## **COMMITTEE UPDATE SHEET**

### SUPPLEMENTARY REPORT OF THE PLANNING MANAGER

22/00168/FUL – Land off Farm Lane, rear of Barn Cottages, Hardstoft

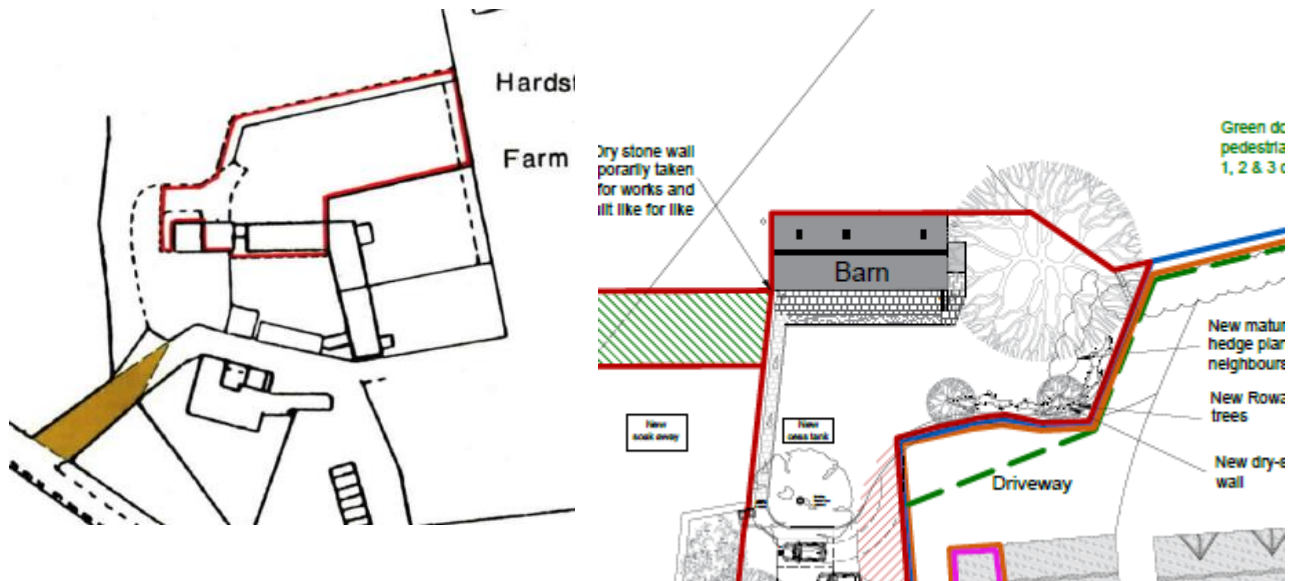
8. Boundary lines are incorrect and inconsistent throughout the application on the existing boundaries and also extended boundaries impacted the local Conservation Plan. The applicant states the “neighbour has access over this area” which is incorrect as it is owned by barn number 3. I have included below a copy of the actual boundary line against title deeds held. It demonstrates that the applicant has made incorrect provision to the Eastern boundary of the development. This encroaches on to land owned by barn number 3 and is neglectful by the applicant as it makes the proposed windows not viable given the distances detailed by the

planning manager. A boundary dispute has been sent to the applicant by the owner of Barn number 3. I have also included photos below that correspond to the boundary on the title deeds (note the location of the private driveway and also start of the strip owned by Barn 3 but access for barns 1&2 in line with the garage as per the plans and designated by a cone)

The “pitching hole style window” to the East gable end would be directly overlooking the private garden of number 3 Barn Cottages. – This is commented upon in the planning manager’s summary of the proposal. It details the measurements from the barn to the boundary. This is incorrect as the boundary line is incorrect on the applicant’s plans. The actual boundary is only 7m meters from the barn and therefore the windows are not suitable and should be rejected as such. The photo (top right) shows the actual boundary and the fact the property is only 7.0m from the boundary, designated by cones.

With regards to point 8 above, the Local Planning Authority has visited the site and measured a distance of 12m from the proposed first floor, side facing bedroom window onto the stone wall boundary and private garden behind, serving Barn 1. This is in excess of the 10.5m recommended in the Successful Places Design Document. Whilst the stone wall is low on this boundary, there is substantial planting along the part of the boundary closest to the proposal, and there is also a mature tree within the application site that will screen views out of the window to some extent. Whilst the Local Planning Authority acknowledge and accept that Barn 1 owns and maintains a strip of land around the edge of the eastern boundary to provide access to the rear of Barns 1, 2 and 3, this strip of land is not included as part of Barn 1's domestic curtilage, which is clearly defined by the existing stone wall. The Local Planning Authority therefore considers that the proposed side facing bedroom window does not overlook the private amenity space serving Barn 1 sufficient to warrant a reason for refusal, or condition requiring the proposed window to be obscured glazed and non-opening.

Point 8 above also makes reference to the strip of land required for access to barns 1, 2 and 3. It is disputed that Barn 1 owns additional land within this area, which has been included in the application site boundary, and within ownership of the applicant. The Local Planning authority carried out a Land Registry check on the 15<sup>th</sup> July for Barn 1 to establish where the boundaries are positioned. An extract from that plan is provided below (left image) along with an extract from the amended L/01 Rev E received on the 21<sup>st</sup> June.

The position of the red line boundary appears to have been drawn correctly on the plans submitted with the application, in comparison with the red line on the official title plan. Notwithstanding that, an advisory note is recommended for inclusion to remind the applicant that in the event a land ownership dispute results in the red line boundary being drawn incorrectly on this application, or a failure to formally notify other land owners within the application site, it could render the application invalid and a revised application be required. The applicant's representative was emailed on the 15<sup>th</sup> July to ask *"Given that there are some shared access provisions, and shared boundaries with other land owners, are you now confident that all land contained within the application site (red line) boundary is within the sole ownership of the applicant, as stated on the signed Part A ownership certificate."* The applicant's representative responded with *"Yes, it is my understanding from the Client that the plans are accurate in that matter."* It is therefore considered that the Local Planning Authority has taken appropriate steps to confirm that the application site boundary is correct, and has informed the applicant of potential consequences if plans are inaccurate.
